**IFB VA701-17-R-0033 – Albany CHP Plant TECHNICAL QUESTIONS AND VA RESPONSE TRACKING SHEET**

Partial revised sketch of drawing MD-101 for clarifying answer to RFI question 7

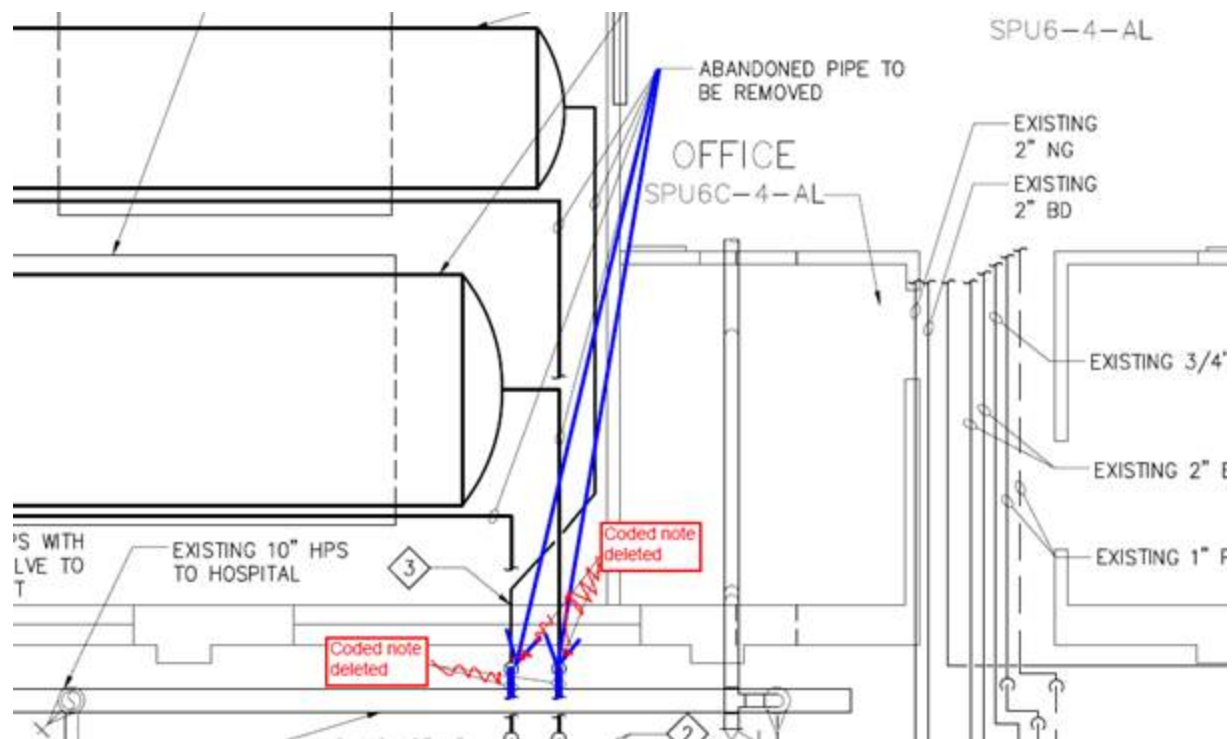
7.	4/3/2017	4/11/2017	On drawing M-1 there are two diamond note #2's indicating where existing abandoned piping is to remain in place. What is the meaning of the second note #2- the one between notes number 1 and 3 is asking for. It almost implies 2 of the 4 pipe may possibly be abandoned in place?	On MD-101, the Note 1 and the Note 2 depicting the piping between the exterior wall and the steam header are to be deleted. The piping that was depicted by the Note 2 shall be "bold" lineweight to indicate it is to be removed. The Note 1 and Note 2 between the steam header and the 6" steam line shall remain. See sketch below for clarification.
